Wizards Workshop

September 19, 1980
Issue 10-19

1430, 1440, 1441, 1460, 1461 - MISSING WASHER ON POWER SUPPLY BOARD,
PART NUMBER CORRECTION

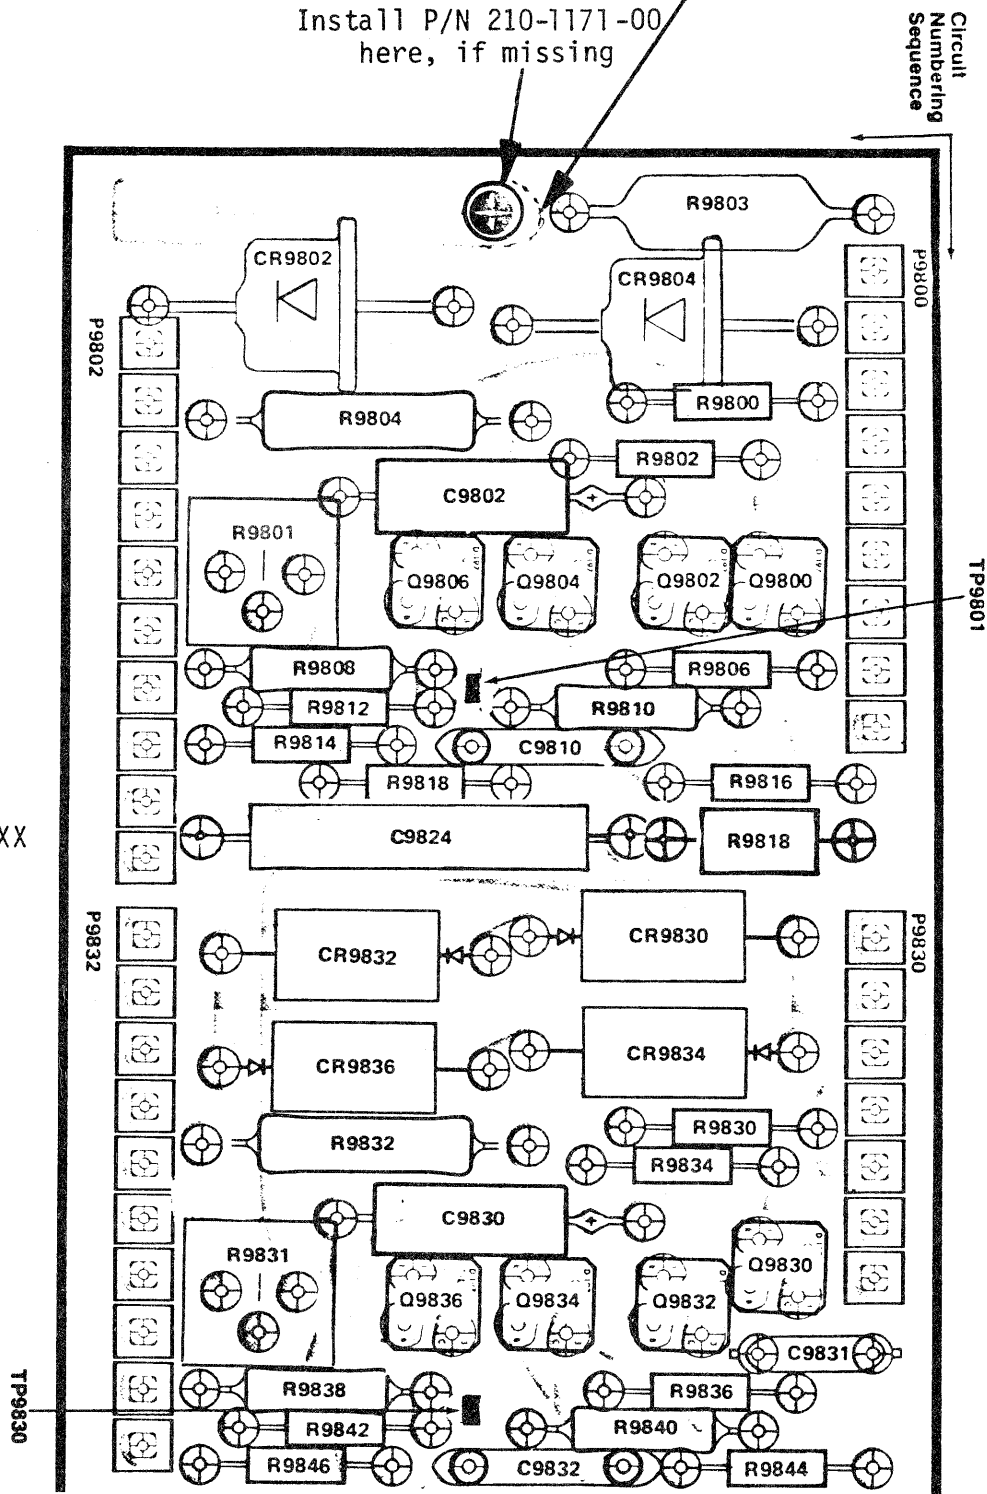
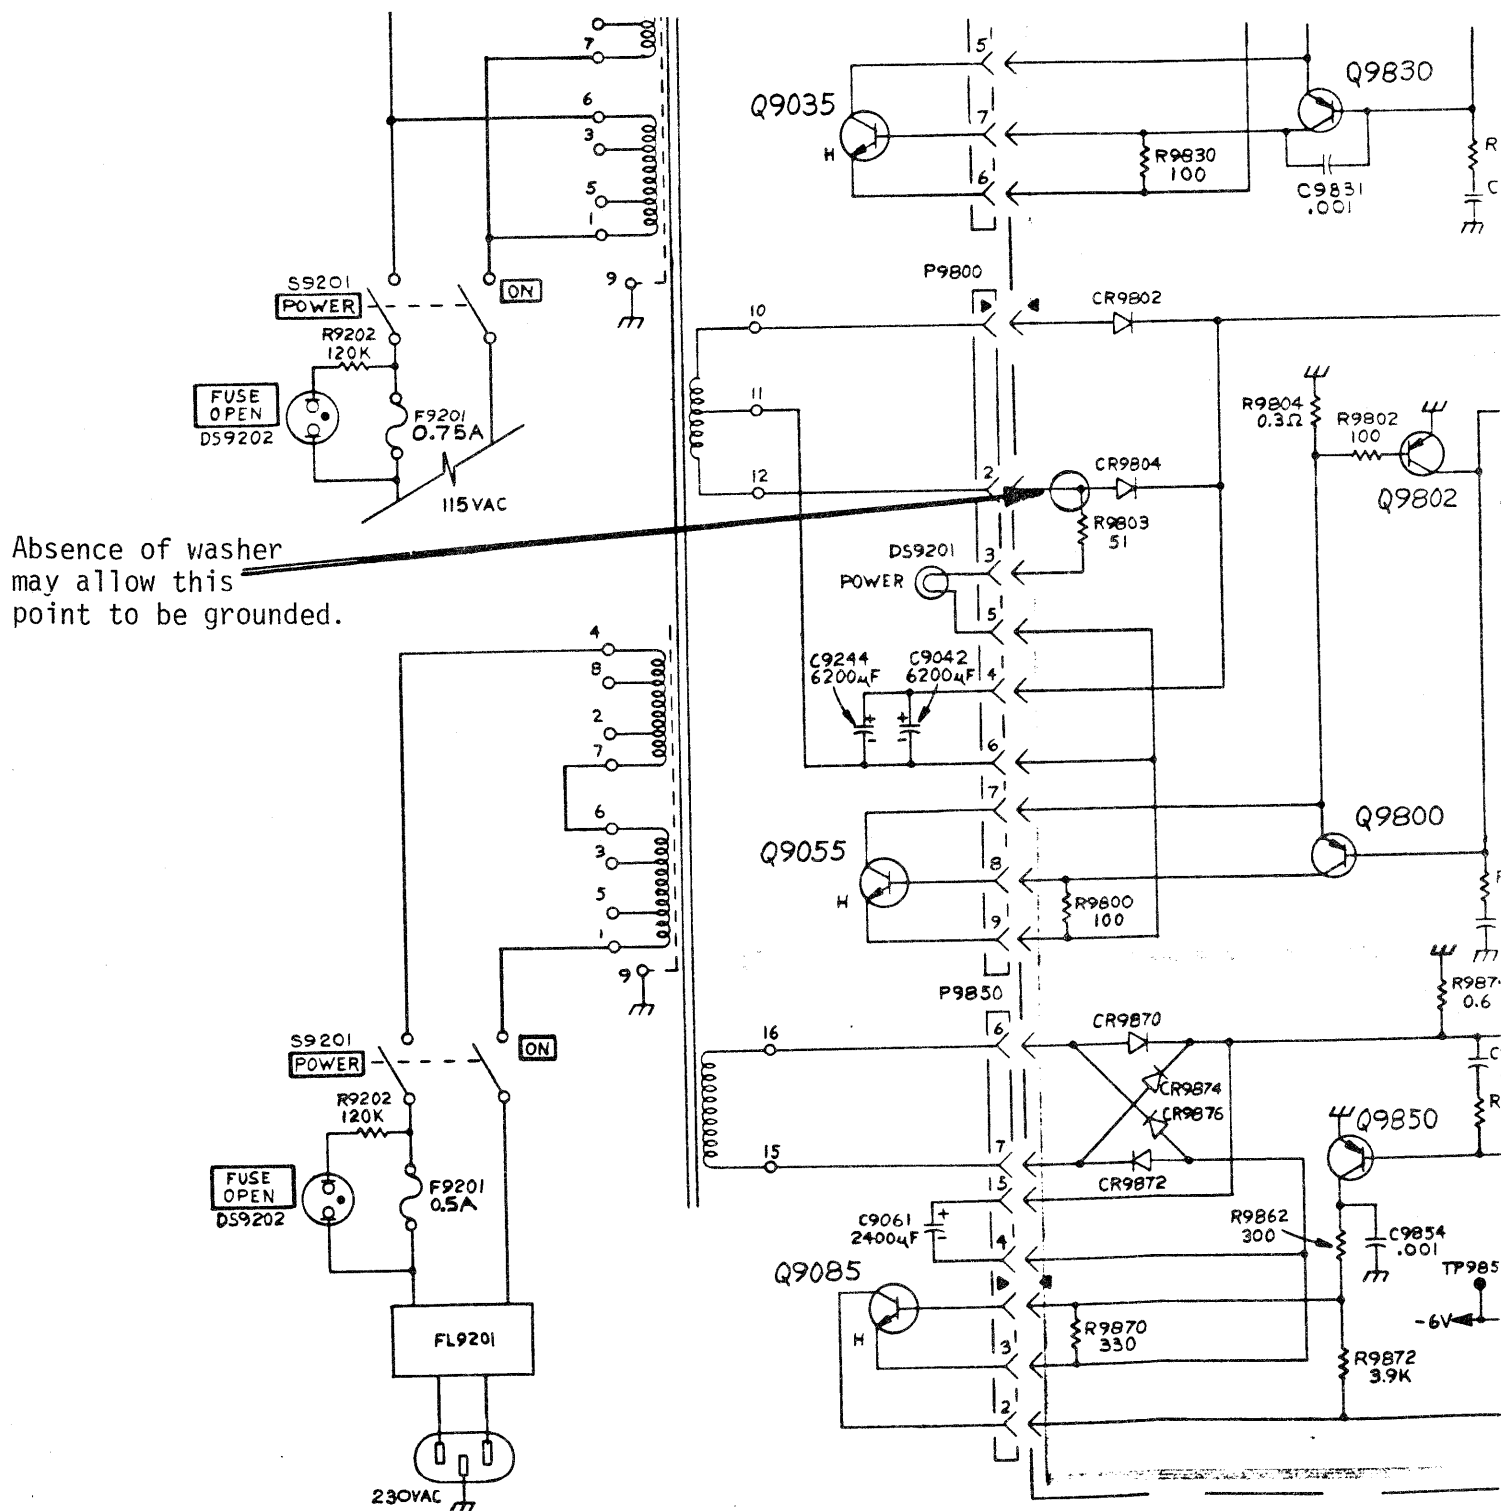
The Manufacturing line had been installing a washer (P/N 210-1171-00) under the metal washer on the board mounting screw that is near R9803 (see the following board layout of power supply board, 670-1473-XX). This washer was to prevent R9803 from being shorted to ground due to close spacing of the circuit board pads. An unknown number of instruments have been shipped without this washer. It is possible that any slippage of the circuit board could cause R9803 to contact the mounting screw. When R9803 is grounded, the +5 volt supply will increase to approximately 9 volts. The power supply is normally not damaged, but other components in the instrument may be.

Please check all 1430, 1440, 1441, 1460, and 1461 instruments that come in for service and insure that a nylon washer is installed and that the power supply mounting screws have remained tight.

If board slips,
short could occur here.

Install P/N 210-1171-00
here, if missing

A16 SECAM FIELD RECOGNITION

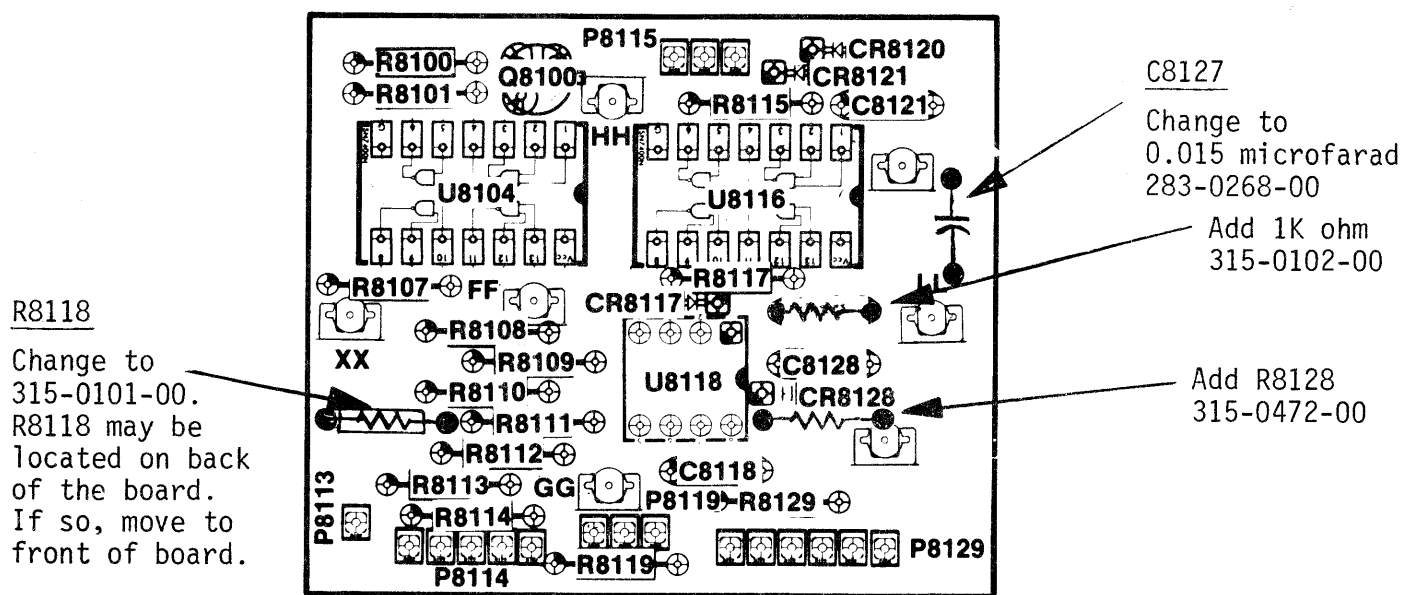
Single frame recognition is interrupted and/or intermittent in the NTSC/PAL mode when a SECAM field one frame pulse is present on J9034. Horizontal jitter will occur on the first serration pulse of field one with horizontal controls set as follows:

To correct these malfunctions, make the following changes on the SECAM Field Recognition Board (P/N 670-5367-00):

1. Change C8127 from 0.005 microfarad (P/N 283-0001-00) to 0.015 microfarad (P/N 283-0268-00).
2. Add a 1K ohm resistor (P/N 315-0102-00) at R8127.
3. Add a 4.7K ohm resistor (P/N 315-0472-00) at R8128.
4. Change R8118 from 1/8 watt, 100 ohm resistor (P/N 317-0101-00) to a 1/4 watt, 100 ohm resistor (P/N 315-0101-00).

464,466 VERTICAL OSCILLATIONS

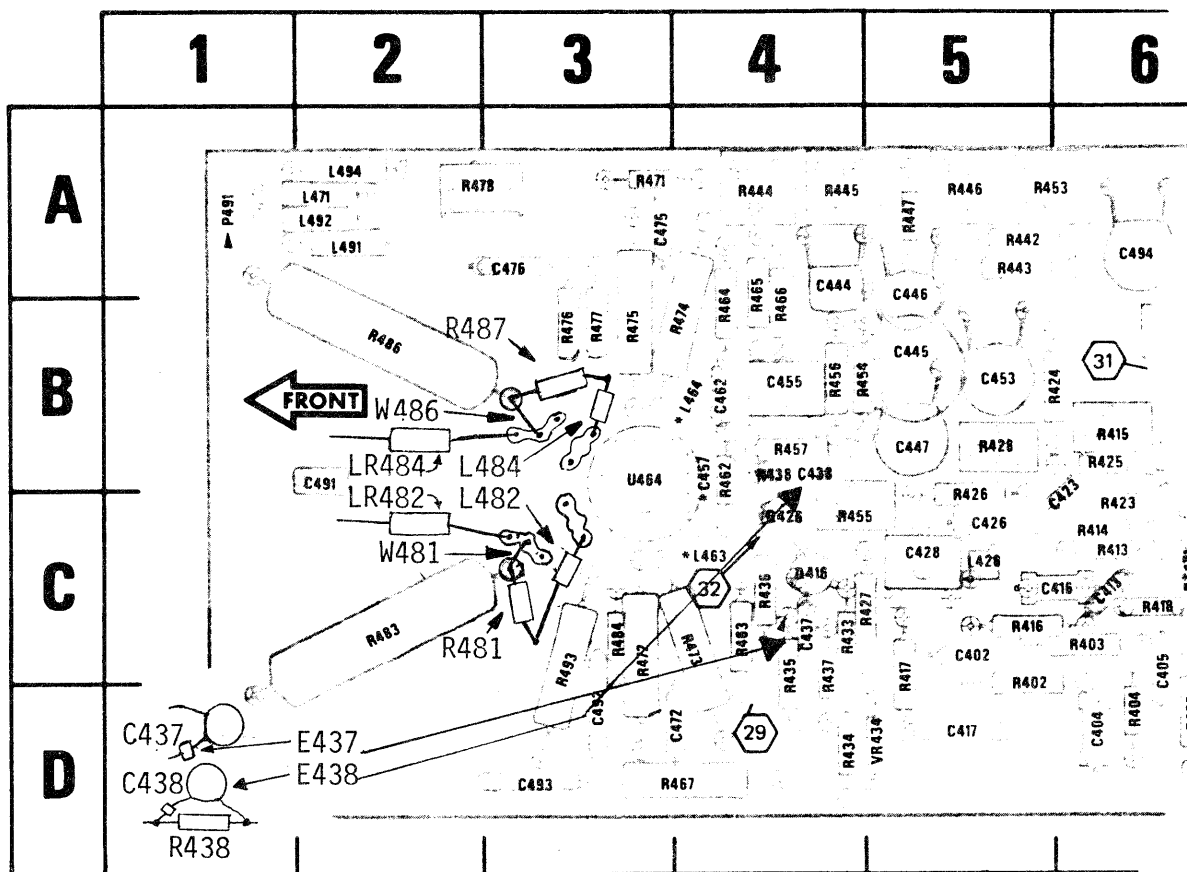
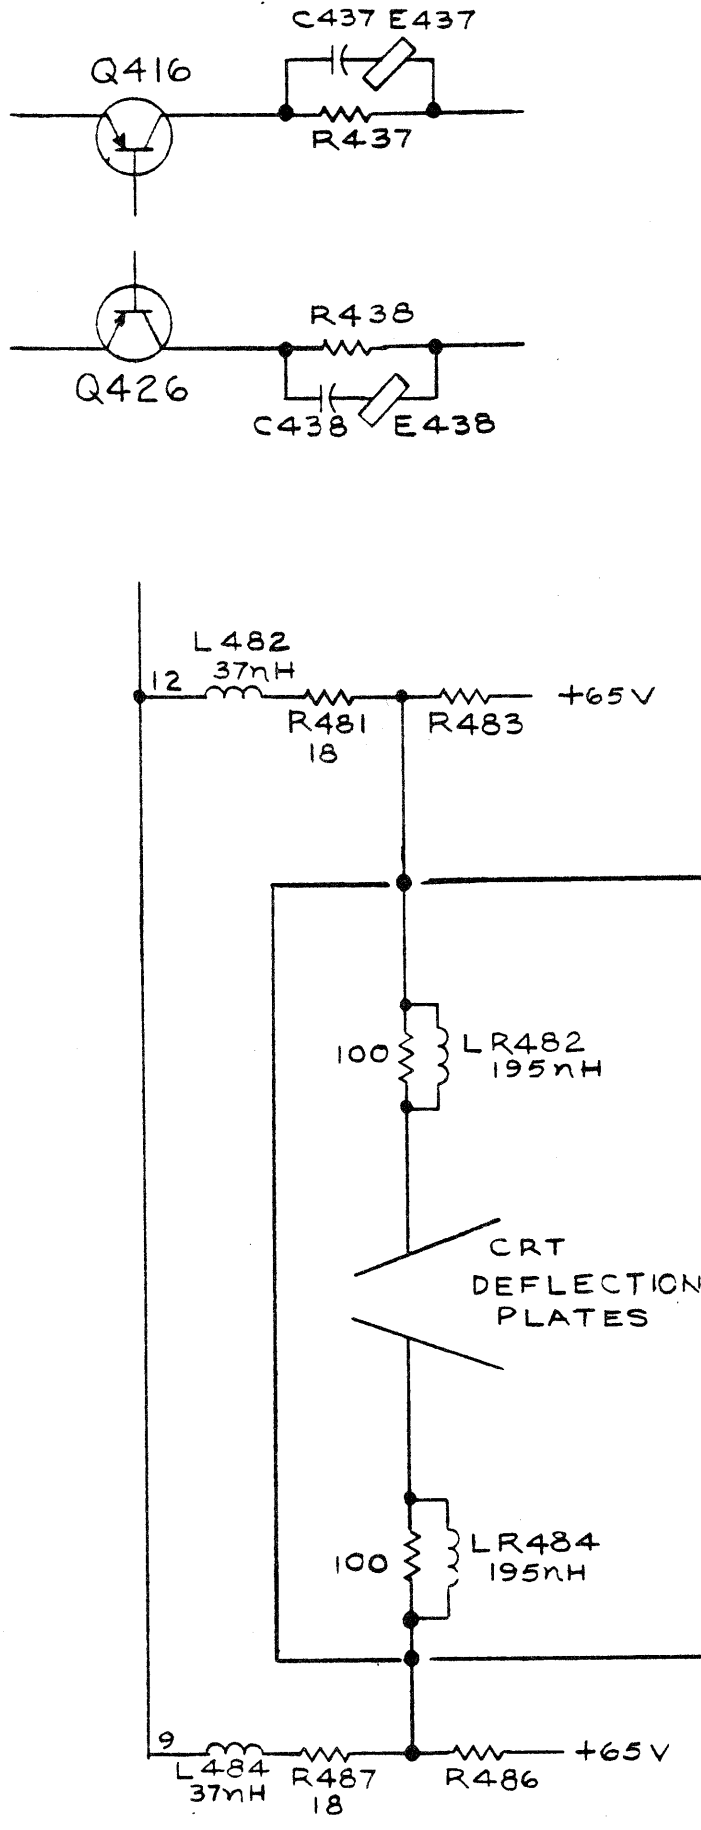
Due to a process change to U464, P/N 155-0115-00 the vertical may oscillate. If U464 is replaced the following modifications must be made:

Remove--

L483 230nH
L486 230nH
R482 10ohm
R485 10ohm

Change-- Old New

LR482 from 97nH to 195nH P/N 108-0729-00
LR484 from 97nH to 195nH P/N 108-0729-00

L482 (L484) 37nH, P/N 108-0606-00 is placed in the series with R481 (R487) 18 ohm, P/N 315-0180-00. R481 (R487) is connected in series with R483 (R486). L482 (L484) is connected in series with Pin 12 (9) of U464. A wire strap W481 (W486) is located from the junction of R481 (R487) and R483 (R486) to LR482 (LR484).

Add E437 (E438) 37 HN P/N 276-0543-00 (shield bead) to C437 (C438), the parts location diagram shows the physical location of the beads. The schematic shows the circuit after the changes have been made.

Illustration 1

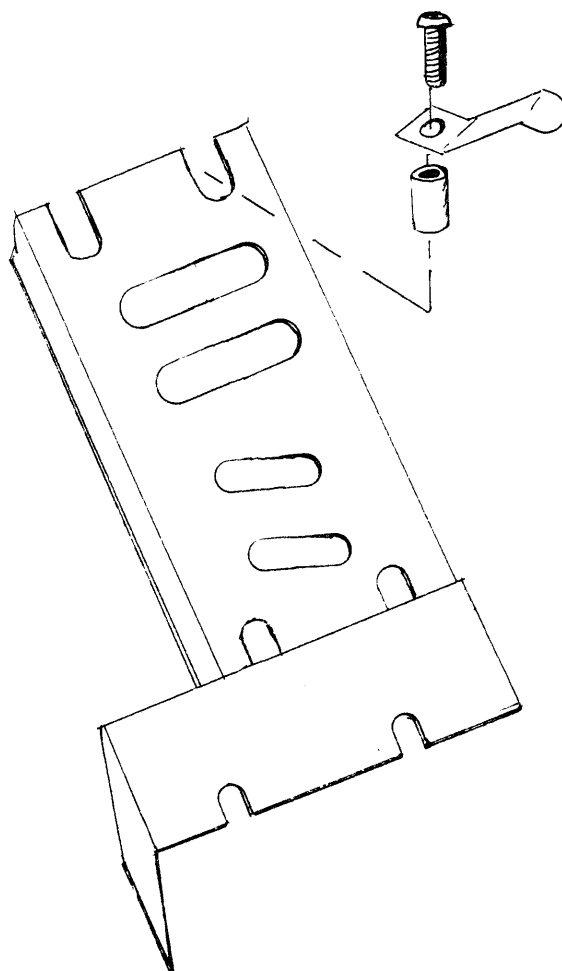
The 5 Volts/Div position on CH 1 and CH 2 vertical preamps may not meet risetime specifications. In order to improve grounding of the attenuator shield, which will improve the risetime to meet specifications, a ground clip is added to the top of the shield (see illustration for location).

The parts added are:	2 ea	P/N 131-1428-00	Ground clip
	2 ea	P/N 166-0030-00	Spacer
	2 ea	P/N 211-0012-00	Screw

Figure 7-43. DCSS Logic Card (A28) Component Locations

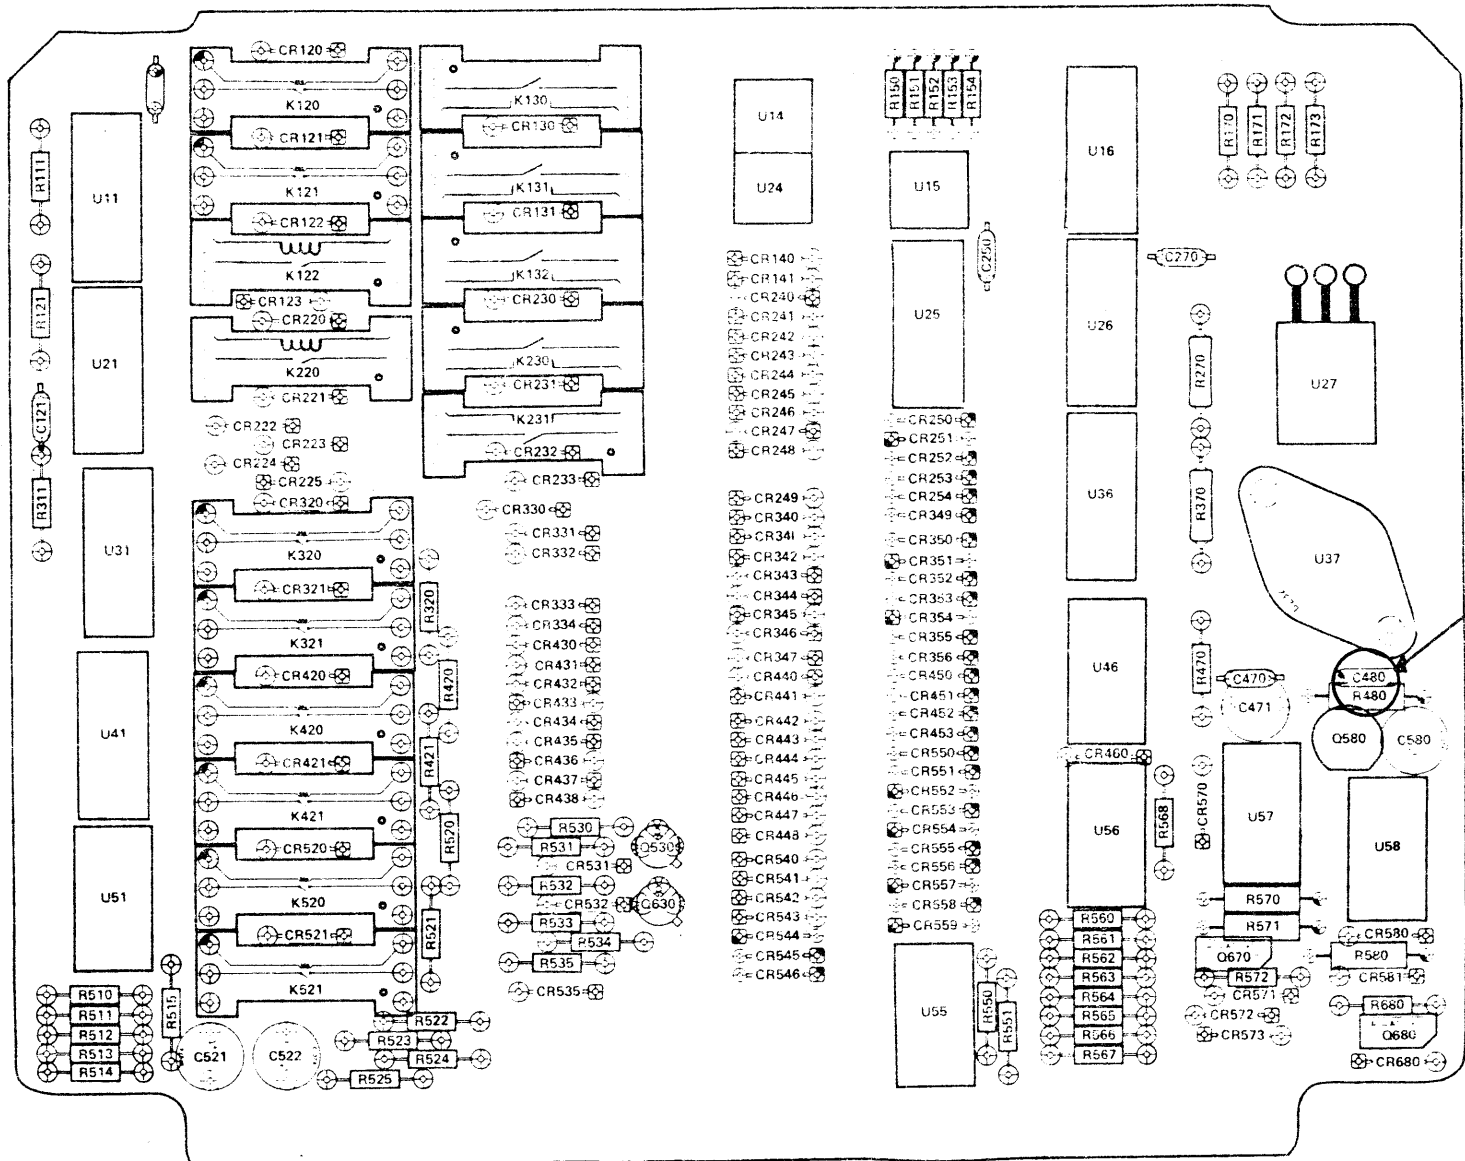
It has been determined in some cases there is an oscillation on the +7V regulator which is coupled to the 15V supply. This oscillation may cause a false initialize signal to be generated. Mod #40301 calls for replacing C480 on the DC Sub-System Logic circuit board. Remove the .001 micro farad capacitor (283-0065-00). Install a one micro farad capacitor (283-0177-00). The assembly number for the DC Subsystem Logic board will change from 670-2828-03 to 670-2828-04. This mod applies to all test tables 1803, 1804 and 1805. See the attached parts placement diagram for the logic Board.

DIAGRAM 'A'

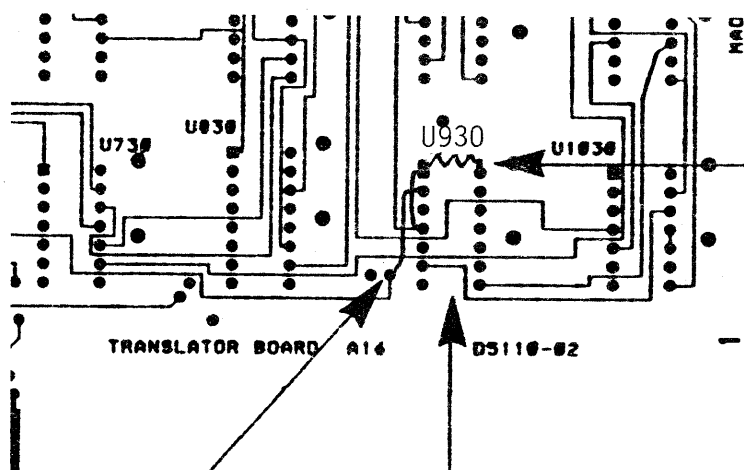
Symptom: An intermittent CKSUM error will be generated when sending waveform data to the computer. An incorrect number of data bytes are generated from the translator board.

Solution: Add a dual D flip-flop (156-0388-02), and a 1K Ω resistor (315-0102-00) on the front side of the translator board (670-4952-00) as shown in diagram 'A'.

1. ADD U935 (156-0388-02) ON TOP OF U930 (PIGGY-BACK). LIFT PINS 1,4,6,8,9,10,11,12, AND 13. TRIM BACK THESE PINS, FOR THEY WON'T BE USED. SOLDER PINS 3,5,7, AND 14 TO CORRESPONDING PINS ON U930.
2. SLIGHTLY LIFT PIN 2 OF U935 AND STRAP TO FEEDTHROUGH HOLE ADJACENT TO PIN 6 & 7 OF U930.
3. ADD R930 (315-0102-00) TO PIN 14 OF U935. TAKE THE OTHER END AND ATTACH IT TO PINS 1 AND 4 OF U935, ENSURING THERE IS AN INSULATED SLEEVING BETWEEN PIN 1 AND PIN 4.

DIAGRAM 'B'

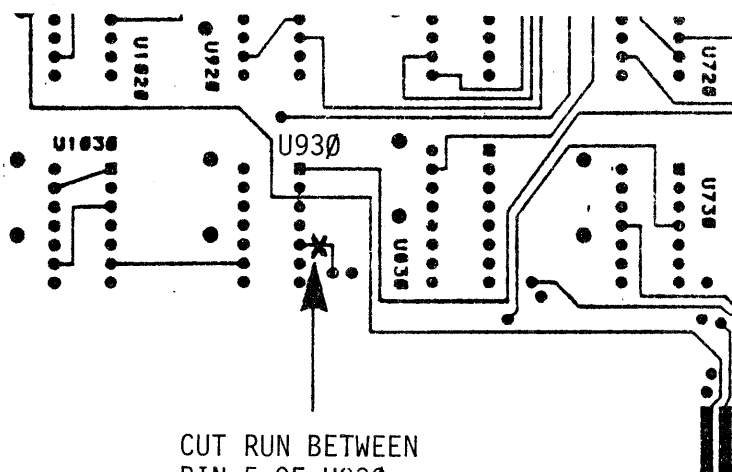
Cut a run between Pin 5 of U930 and a feedthrough hole adjacent to Pin 6 of U930 as shown in diagram 'B', on the backside of the translator board.

CUT RUN BETWEEN
PIN 5 OF U930
AND FEEDTHROUGH
HOLE ADJACENT TO
PIN 6 OF U930.
